**Glenageary Gate LRD, Glenagery, Dun
Laoghaire, Co. Dublin**

Stage 1 Storm Water Audit

212178-PUNCH-XX-XX-RP-C-0002-SWA

SHEET TITLE

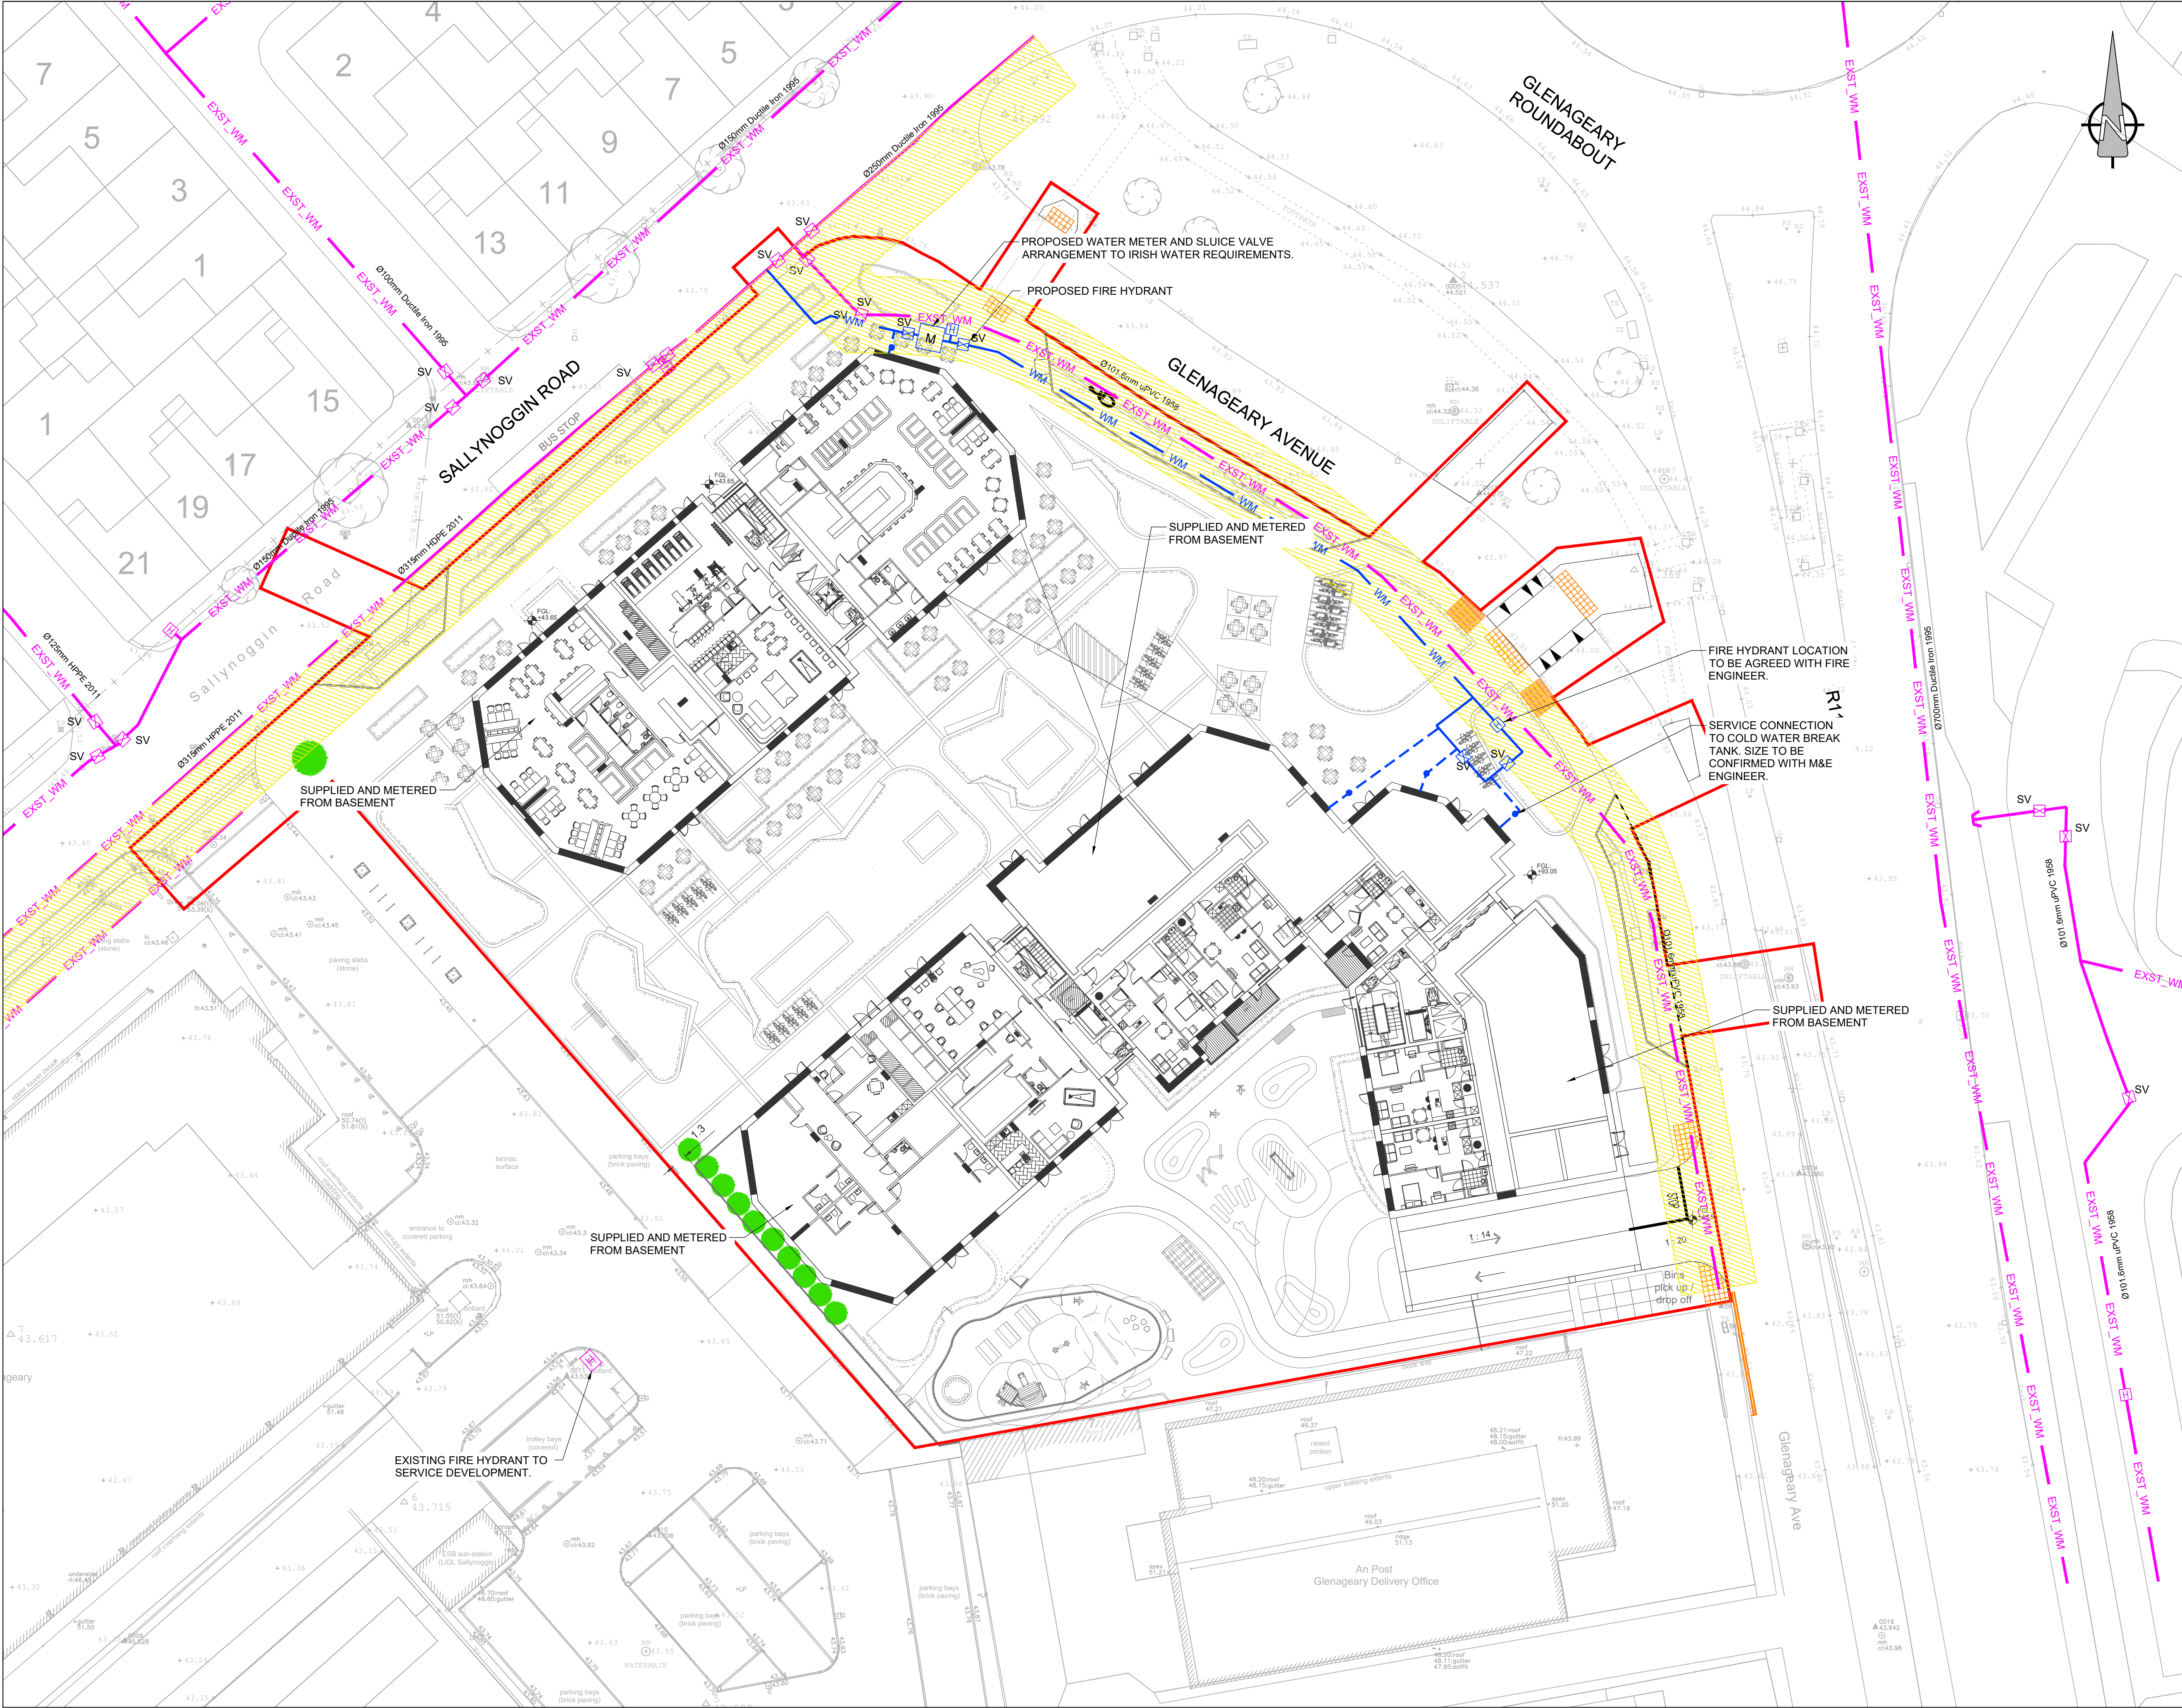
2.1.4	Utility Clash Check The Scheme Designer must undertake a utilities clash check to ensure all utilities' vertical and horizontal separation distances can be provided throughout the scheme. The Scheme Designer should demonstrate this with cross-sections at critical locations such as junctions, site thresholds and connection points to public utilities. Minimum separation distances must be in accordance with applicable Codes of Practice.	Scheme designer to confirm.

2.1.4	The Scheme Designer must undertake a utilities clash check to ensure all utilities' vertical and horizontal separation distances can be provided throughout the scheme. The Scheme Designer should demonstrate this with cross-sections at critical locations such as junctions, site thresholds and connection points to public utilities. Minimum separation distances must be in accordance with applicable Codes of Practice.	Scheme designer to submit evidence of utility clash check with cross-sections.	Please refer to the MicroDrainage long sections and crss section's added to drawings.	Yes
